GARDINER EXPRESSWAY AND LAKE SHORE BOULEVARD EAST RECONFIGURATION ENVIRONMENTAL ASSESSMENT

Appendix R - Third Party Proposals Assessment

February 2016

Figure 1: The Viaduct Plan

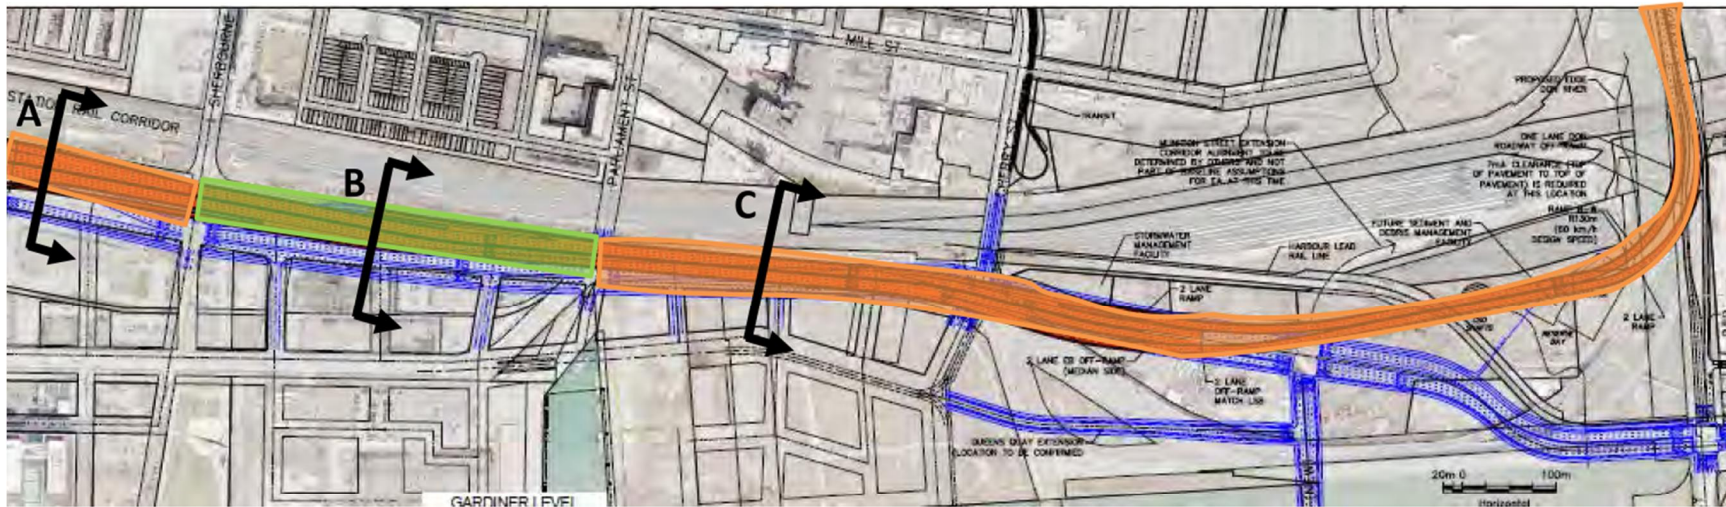
- Creates a section of bermed expressway / open-air Lake Shore Boulevard from Sherbourne Street to Parliament Street with two-sided development;
- A lower elevated expressway profile through a portion of the corridor would improve views across the corridor to the waterfront; and,
- Reduces lifecycle costs for the bermed expressway section.

- Due to right-of-way width restrictions, only 425meter of viaduct (expressway supported by a berm) is possible in the 1700 meter corridor (Jarvis Street to Don River);

- Requires property acquisition (12 sites) which would be costly and result in lengthy private landowner negotiations;
- Results in throwaway Gardiner rehabilitation costs (the existing Gardiner requires major rehabilitation to commence by 2018/2019. It is expected that construction on the Viaduct concept could not commence until about 2021/2022 and would take eight years to construct. As such, full east deck rehabilitation would be required;

- Extra \$485 million (2013\$) over Hybrid costs plus an estimated \$45-\$50 million for property acquisition from 12 parcels; and,
- Lengthens pedestrian crossing distances at some north-south streets and requires pedestrians to pass under an elevated expressway that is lower than current deck height.

Regarding the Viaduct concept, due to right-of-way width restrictions within the corridor, to avoid significant private land takings, a true “bermed” viaduct is only available for about 425 meter of the 1700 m length from Jarvis Street to the Don River. The rest of the expressway would need to be supported by a bridge structure with Lake Shore Boulevard lying under or partially under the expressway as in the current condition. Given the limited benefit of this option, its high cost and approvals uncertainty as a result of the significant land requirements, this concept is not recommended for further consideration in the EA.

Figure 3: Green Gardiner Plan and Section Drawing

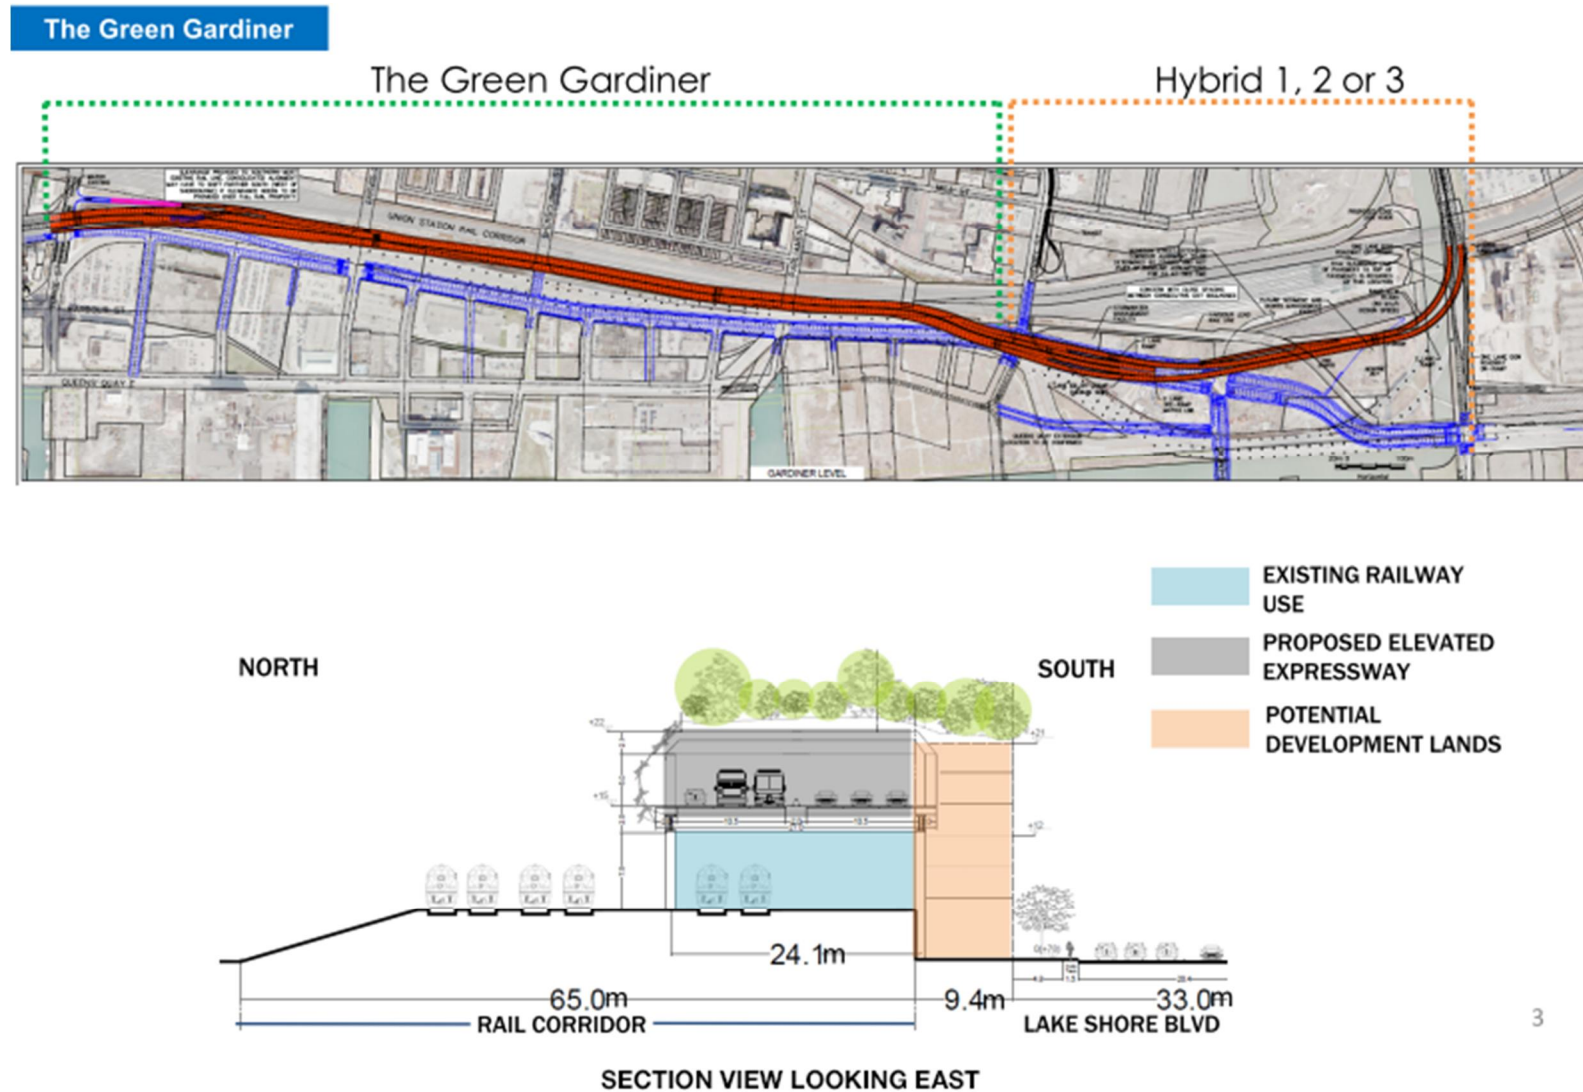
- 1.1 km of open-air Lake Shore Boulevard with the opportunity for two-sided development;
- Additional three hectares of public land released for development at an estimated value of \$130 - \$145 million; and,

- Lengthy and uncertain Metrolinx approvals process – Metrolinx has indicated that they need flexibility for future expansion of rail tracks in the corridor to accommodate the planned Regional Express Rail project, and are not in a position to provide comment on the placement of columns/piers that would be needed to support an elevated expressway over the rail corridor;

- Results in throwaway Gardiner rehabilitation costs. The existing Gardiner requires major rehabilitation to commence by 2018/2019. It is expected that construction on the Green Gardiner concept could not commence until about 2021/2022 and would take 8-10 years to construct. As such, full east deck rehabilitation would be required;

- Extra \$735 million (2013\$) over Hybrid costs plus additional cost for rail corridor air rights;
- Potential for local neighbourhood noise, air quality and view impacts;

- Removal of westbound exit at Sherbourne/Jarvis increases travel time for some commuters; and,
- Required westbound off-ramp at Munition Street reduces open space and impacts Keating Precinct.

The Green Gardiner concept would require the approval of Metrolinx which has advised that until their long term needs for the rail corridor are determined, they cannot support placement of road-related infrastructure in the rail corridor that might impact future rail expansion plans including the Regional Express Rail (RER) program. Even if Metrolinx was in a position to support this concept at this time, it is expected that approvals, design and construction of this concept would take until about 2030 thus it would be necessary to undertake the planned east Gardiner rehabilitation program, which needs to be initiated by 2018/2019 to ensure safe travel on the Gardiner. For these

reasons this proposal is not being considered further in this EA but could be considered in the longer term by City Council once Metrolinx has confirmed their RER plans and determined their long term rail corridor needs.
